SITE PLAN - OPTION FOUR

SHEET: A2

GYROPOLIS REDEVELOPMENT  
BLOOMINGTON, MN

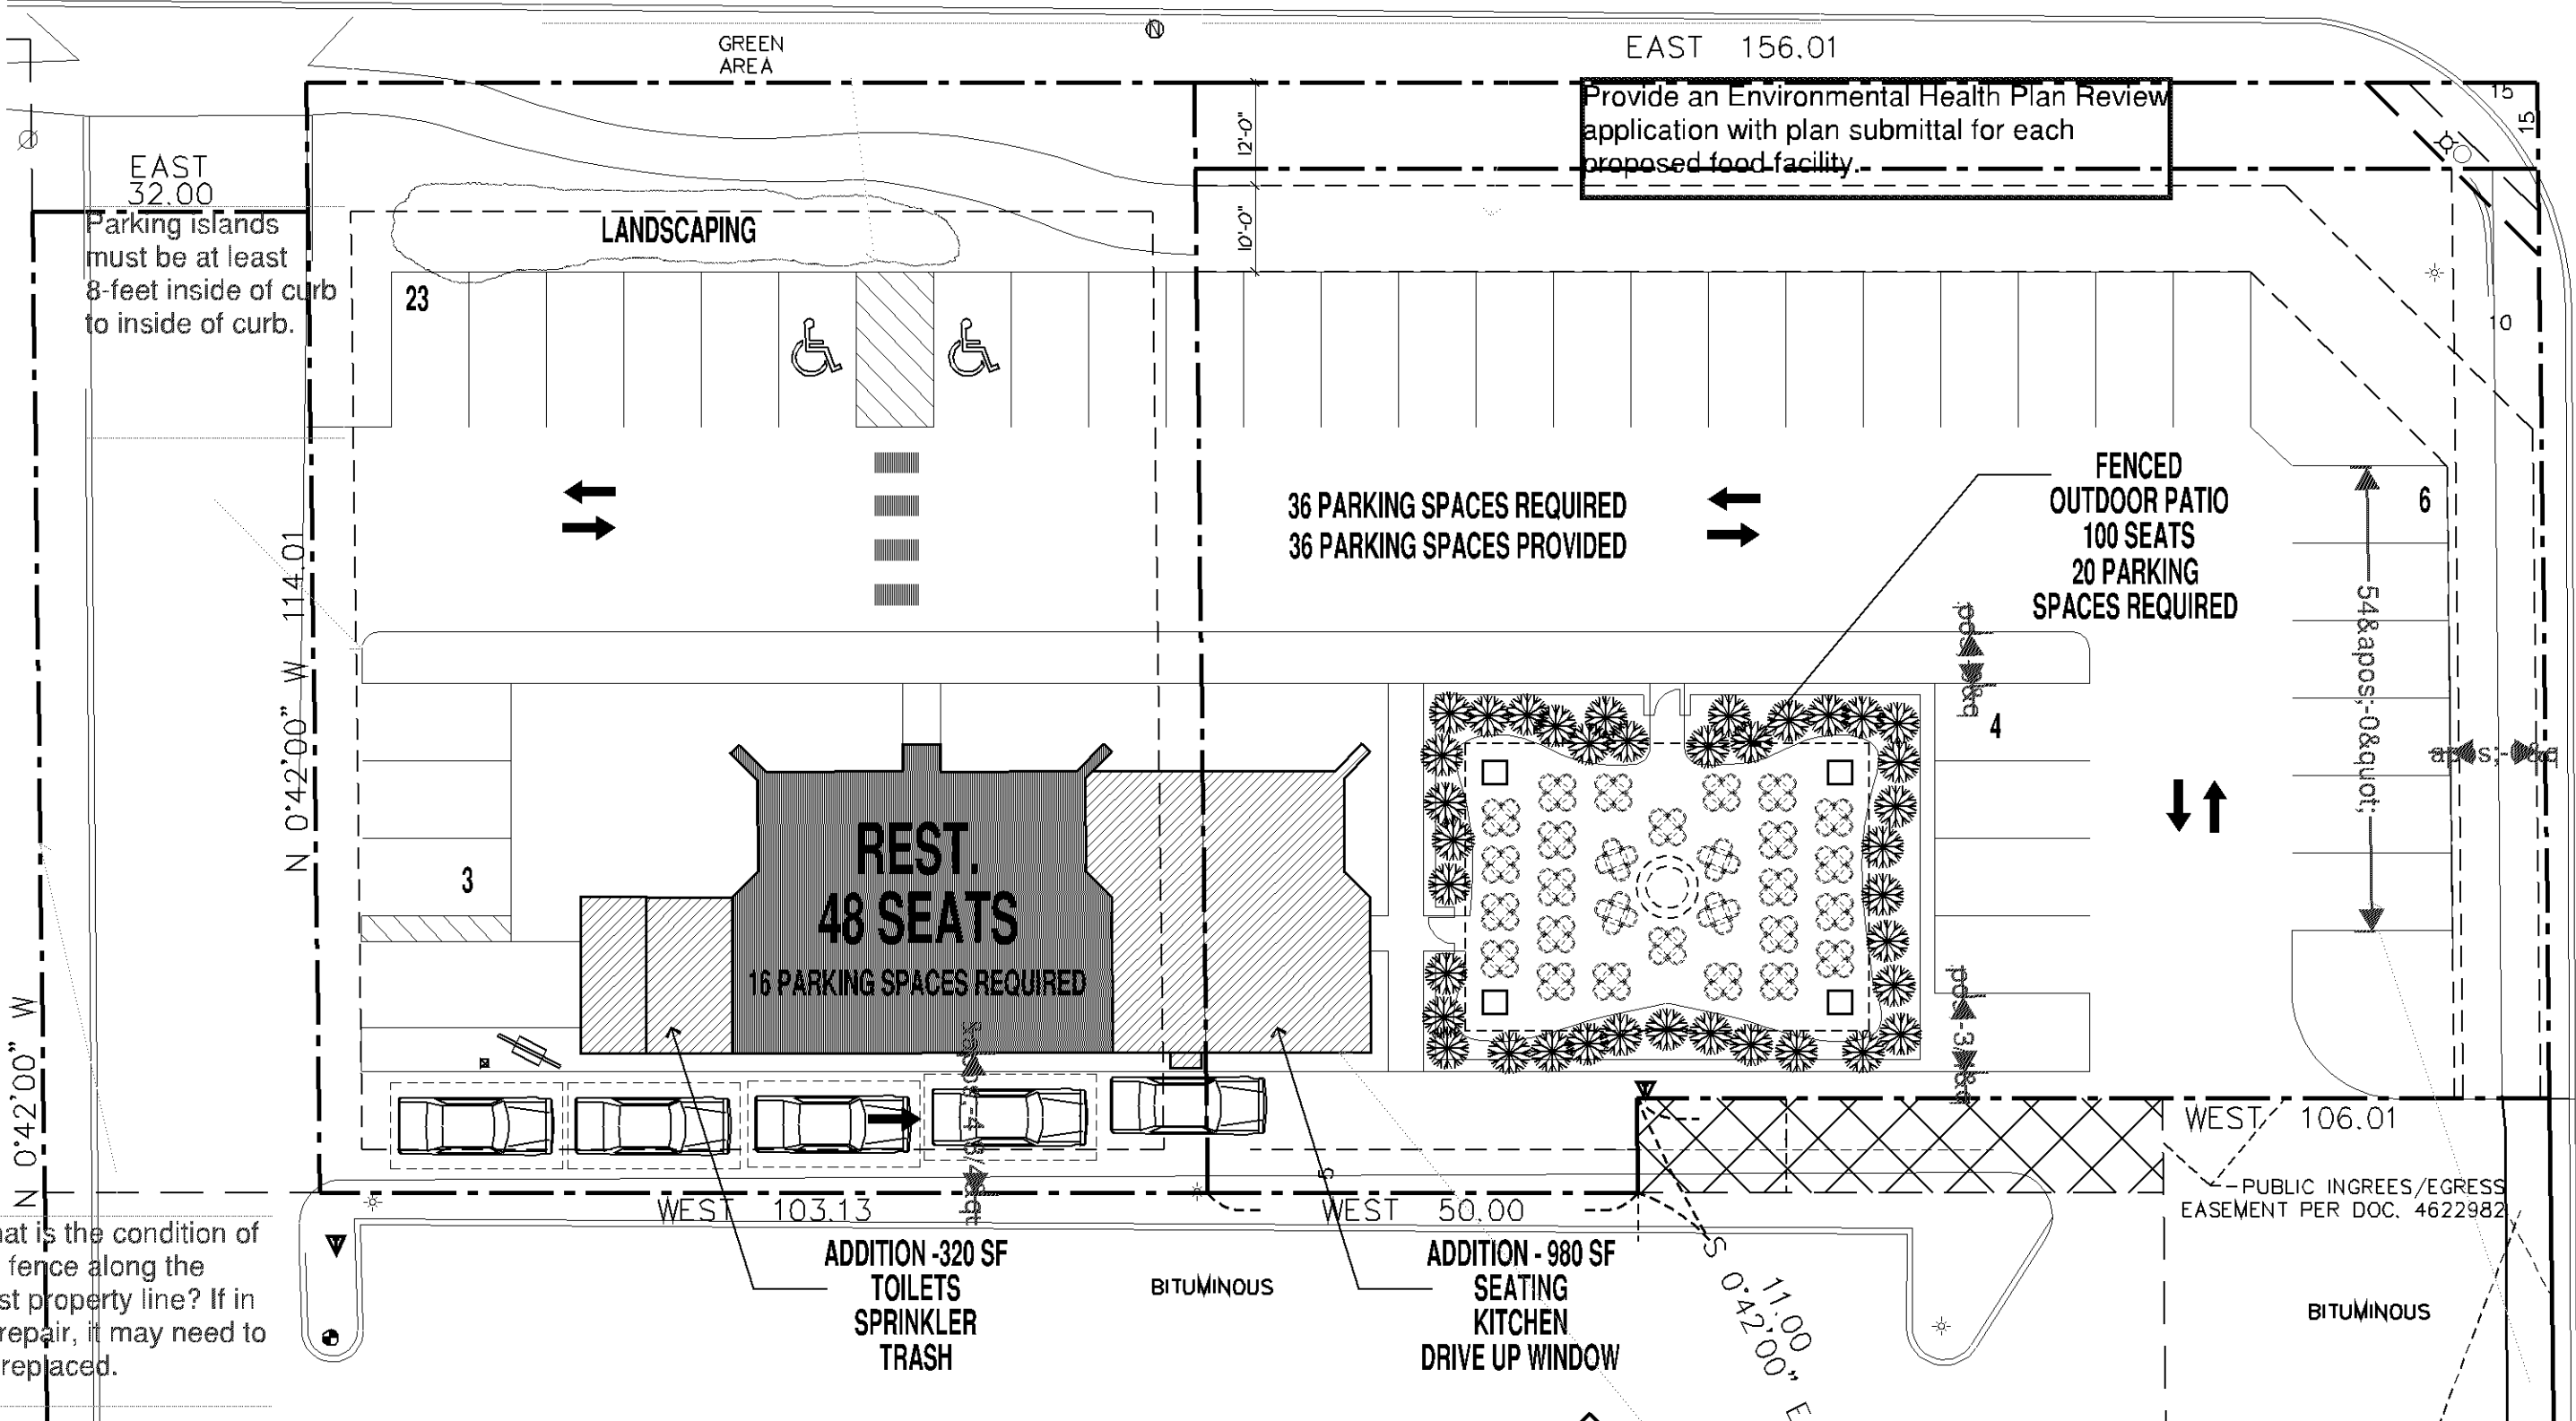
Per 1306, with the addition to the restaurant, the building will be required to be sprinklered and a code complying monitored fire alarm system.

The kitchen hood(s) shall be protected by a UL listed and code complying system connected to the building sprinkler system.

Provide emergency vehicle access and circulation for ladder 3.

Ensure hydrant coverage within 150' of exterior walls of the building.

Show the sidewalk impacts along 90th St and Penn Ave. It's hard to tell what will be impacted with this redevelopment.

Include a sidewalk connection to accessible stall striping.

Include the Code required 8-foot concrete sidewalk along 90th and along Penn.

Building plans must be signed by a MN licensed architect.

Must meet 2020 MN State Building Code

SAC review by MET council will be required.

Must meet 2020 MN Accessibility Code.

Provide a detailed code analysis with the plans.

With the menu board, the site plan seems to indicate a drive-through window. Locate window as far east as possible in order to meet the 6-stall stacking space requirement

Could the eastern most stalls along Penn be shifted west to accommodate a wider landscaping yard?
